**Item 3.****Development Application: 888 Bourke Street, Zetland - D/2021/514****File No.:** D/2021/514**Summary****Date of Submission:** 13 May 2021

Amended drawings and additional information received on 11 October 2021 and 17 November 2021

**Applicant:** Toplace Pty Ltd**Architect/Designer:** PTW Architects**Developer:** Toplace Pty Ltd**Owner:** 888 Place Pty Ltd**Planning Consultant:** LJB Urban Planning**Cost of Works:** \$3,220,228**Zoning:** The site is located in the B4 Mixed Use. The proposed development is defined as residential accommodation and is permissible with consent within the zone.**Proposal Summary:** Consent is sought to amend the approved design under the base development consent D/2020/93 (Stage 2 consent for detailed built form) for the change of use of the 89 serviced apartments in Building A to 90 residential apartments. This also includes reconfiguration of the basement levels and parking and consequential design changes.

**Figure 33:** Approved rooftop terrace plan outlining the areas of communal open space to be removed as per condition 4 of D/2020/93

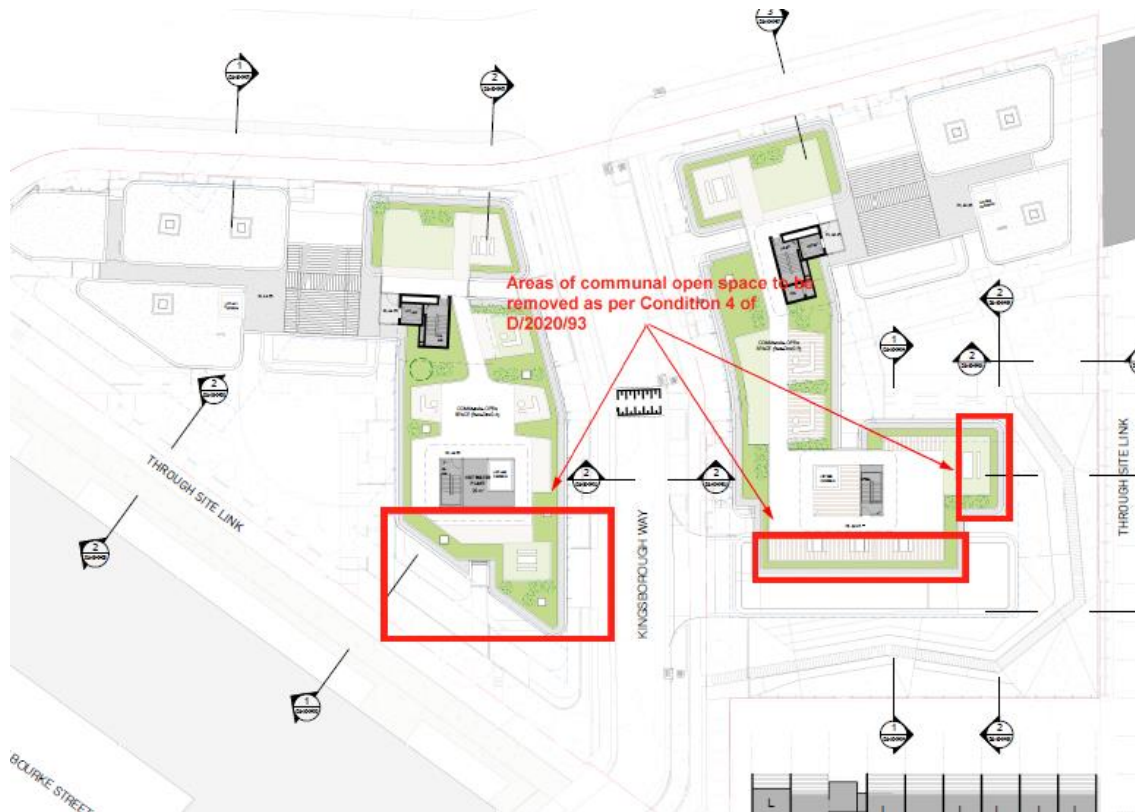
81. Rooftop communal open spaces with the areas of 519.45sqm for Building A and 670.1sqm for Building B has been approved under the base consent. Due to concerns on adverse visual privacy and noise impacts to the neighbouring properties at 890-898 Bourke Street and 15 and 17 Joynton Avenue, Condition 4 Communal Open Space was imposed under the base consent requiring the design of the rooftop communal open spaces to be modified to reduce the extent of useable communal areas as follows (see Figure 33):

- (a) Building A communal open space is to be setback in line with the south-west lift overrun/hot water plant and fire stair structure. All area beyond this point to the edge of the rooftop is to be replaced with appropriate landscape treatment to provide a visual privacy buffer 890-898 Bourke Street.

- (b) Building B communal open space is to be setback from the south-east, south and south-west and replaced with appropriate landscape treatment to provide a visual privacy buffer to 15 and 17 Joynton Avenue as follows:

82. The rooftop communal areas as shown in the propose level 7 and rooftop plan (see Figure 34) has been modified to address Condition 4 of the base consent and therefore this condition can be deleted. It is noted that the reduction in communal open space will still allow the subject site to achieve 25% as per Part 3D-1 ADG with a total area of 1944.06sqm (28%) of communal open space being provided for the site i.e. rooftop communal open spaces with the areas of 411.67sqm for Building A and 544.4sqm for Building B has, and ground level communal open spaces with the areas of 349.84sqm for Building A and 638.15sqm for Building B. It is also noted that these changes do not increase height as it is reducing the communal area built form, not adding more.
